Packet Guide
City of Charlottesville
Board of Architectural Review
Regular Meeting
June 17, 2025 5:30 p.m.
Hybrid Meeting (In-person at Council Chamber and virtual via Zoom)

**City of Charlottesville
Board of Architectural Review
Staff Report
June 17, 2025**

Exterior View Window C-3

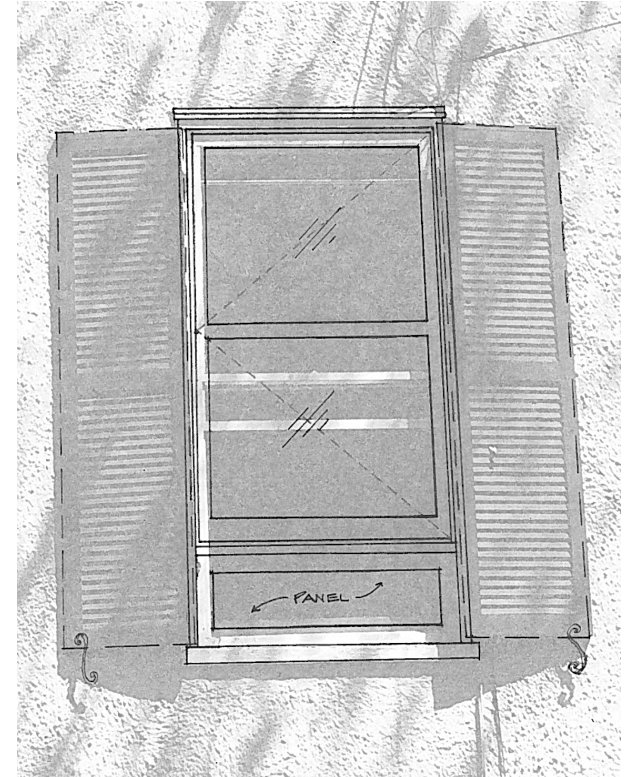
- b. Main Level C-7:
 - i. (2) double hung windows similar to the paired double hung windows above, to replace non-original single fixed window, refer to diagram window type C-7.

3. PEDESTRIAN ENTRANCE ON MARKET STREET

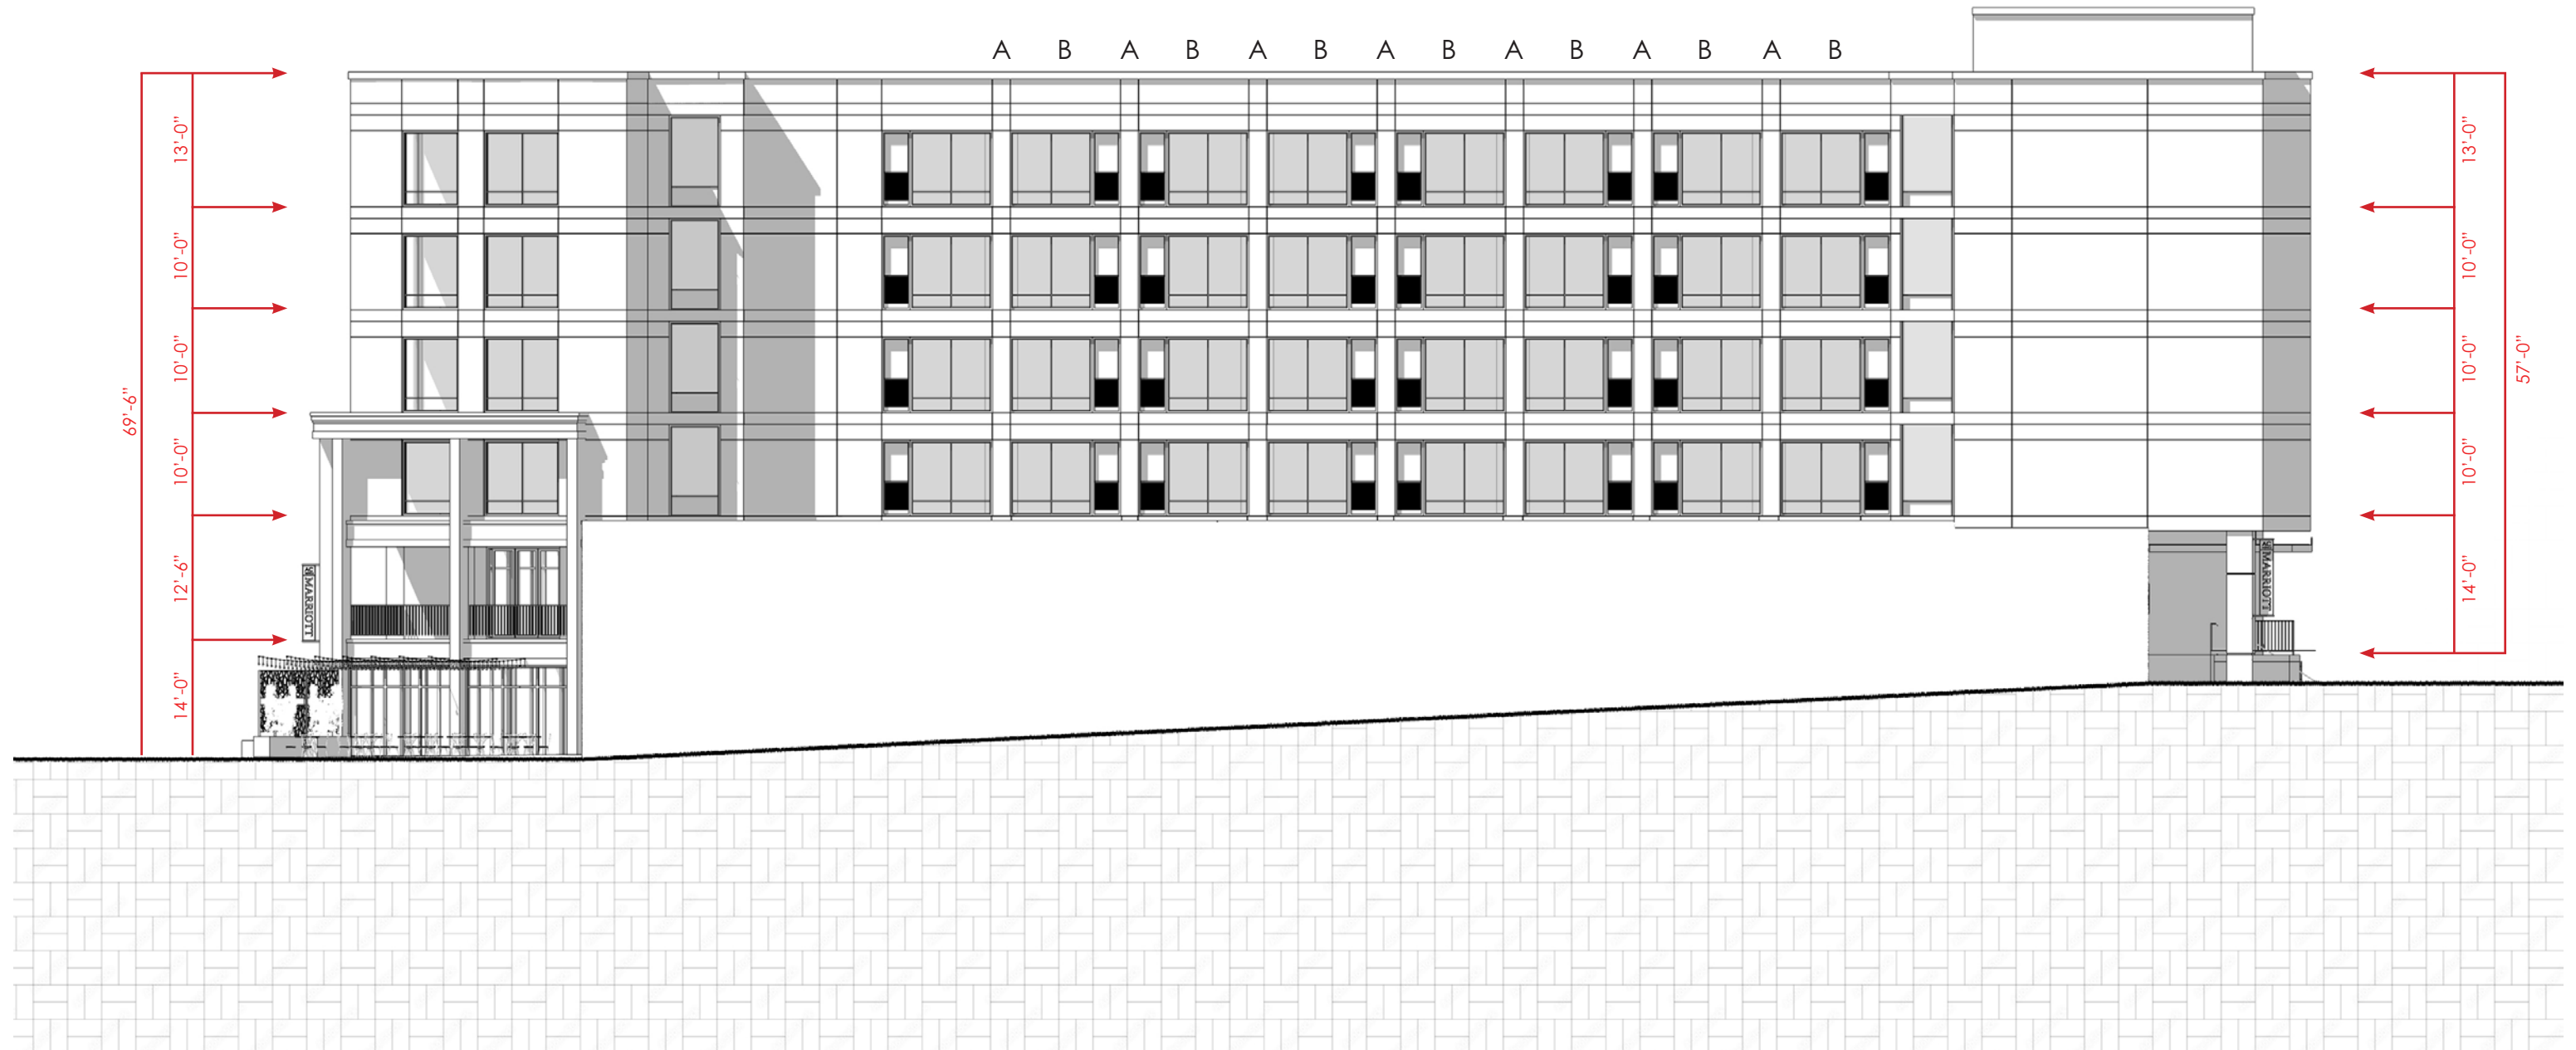
- Reduce the height of the retaining wall(s).
- Add pedestrian lighting. For ex, BAR mentioned stair lights.

THE TALL BRICK WALL ALONG MARKET STREET HAS BEEN LOWERED AND BROKEN UP WITH PLANTERS AND PRIVACY SCREENS, CREATING A MORE INVITING EDGE AND PULLING THE PUBLIC PATIO BACK UNDER THE CANOPY. THE SAME PRIVACY SCREEN IS USED ON THE OLD PRESTON AVE SIDE TO SUBTLY DEFINE AND SCREEN THE PRIVATE HOTEL PATIO.

ADDITIONAL ACCENT LIGHTING BY THE ENTRANCE WILL BE FINALIZED AS DESIGN PROGRESSES AND EFFECTS ON PHOTOMETRICS CAN BE STUDIED IN DETAIL.

THIN BRICK TAB SYSTEM DETAIL
218 WEST MARKET STREET

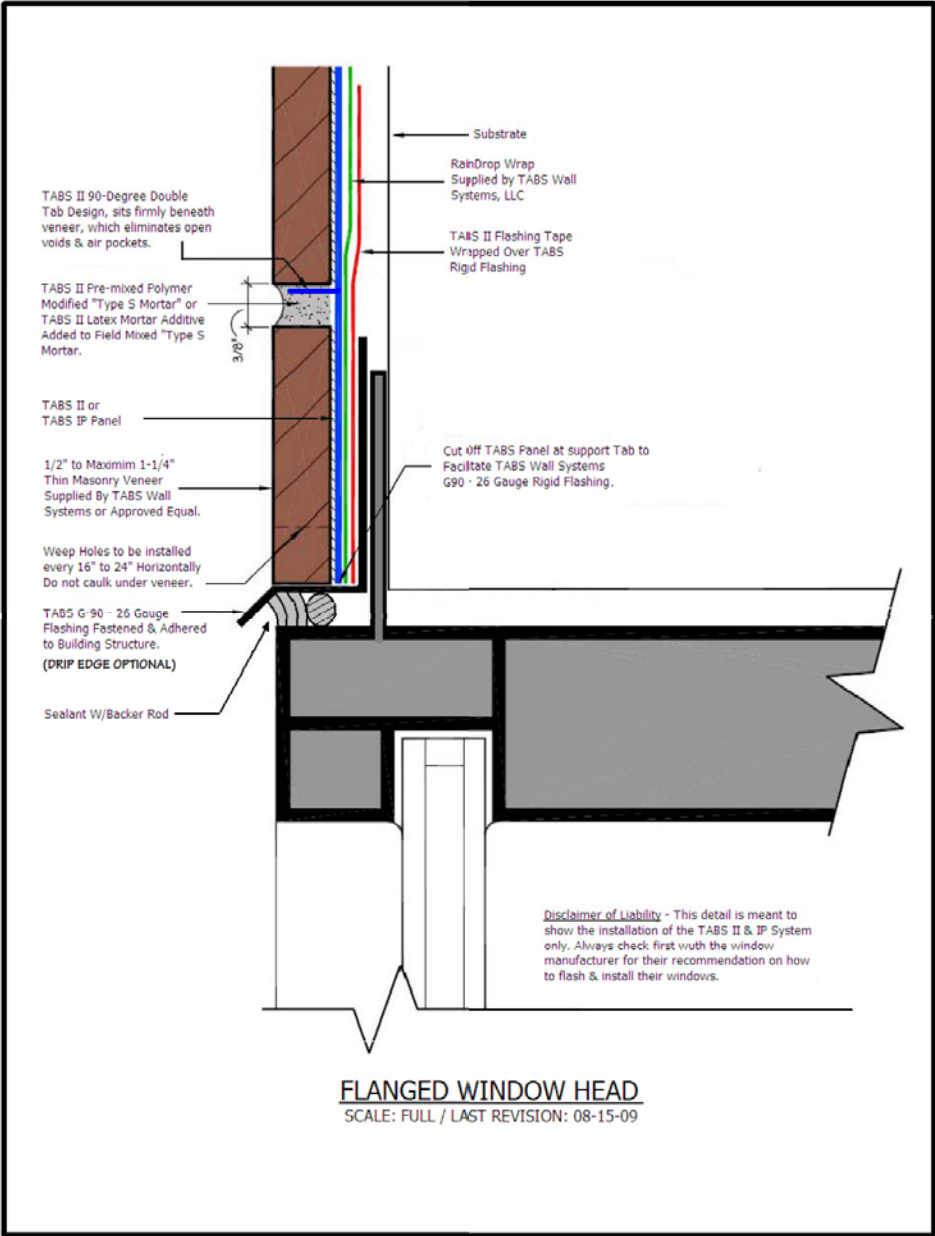
- Provide a spec for the thin brick system. Will it have TABS II Rain Screen or something equivalent behind this system?
- Provide a spec for the stucco. Don't need a CSI Masterpiece, provide description the various components/systems.
